2015/11/09

MVSC/AA/HD/MA/MB-220-4*
MVSC/AA/MA/MB-300-4* series
Exterior Design Change Notification

A.MVSC-220-4E*、MVMB-220-4*、MVAA-220-4*、MVHD-220-4*
Exterior Change : Example: MVSC-220-4E*

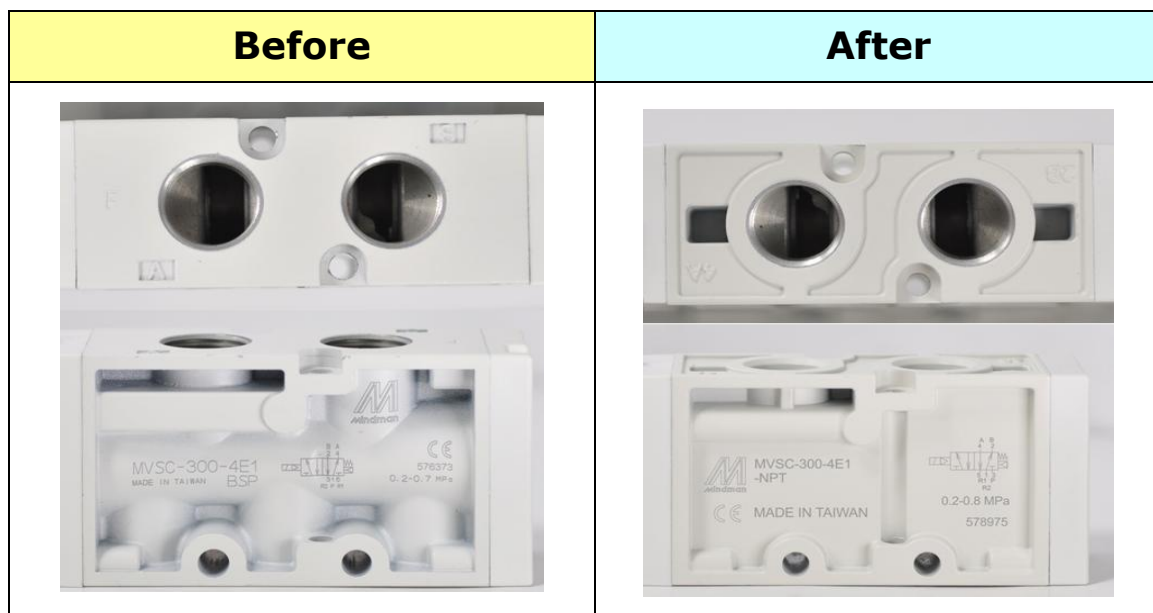
Note : There is a sticker on MVMB-220-4* series instead of laser printing.

B.MVSC-300-4E*、MVMA-300-4*、MVMB-300-4*、MVAA-300-4*
 Exterior Change : Example: MVSC-300-4E*

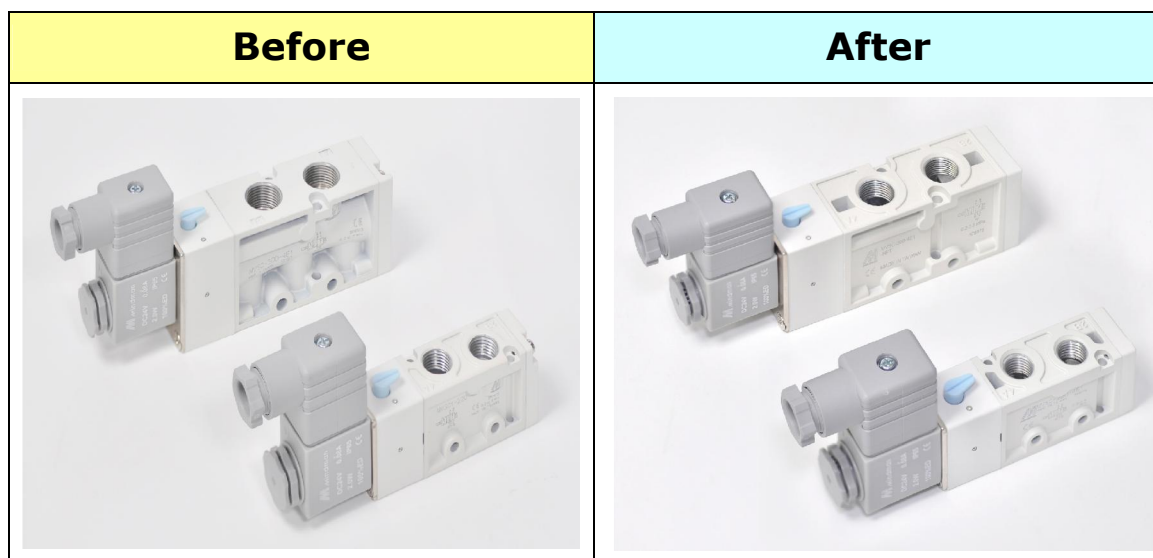
There is a sticker on MVMB-300-4* series instead of laser printing.
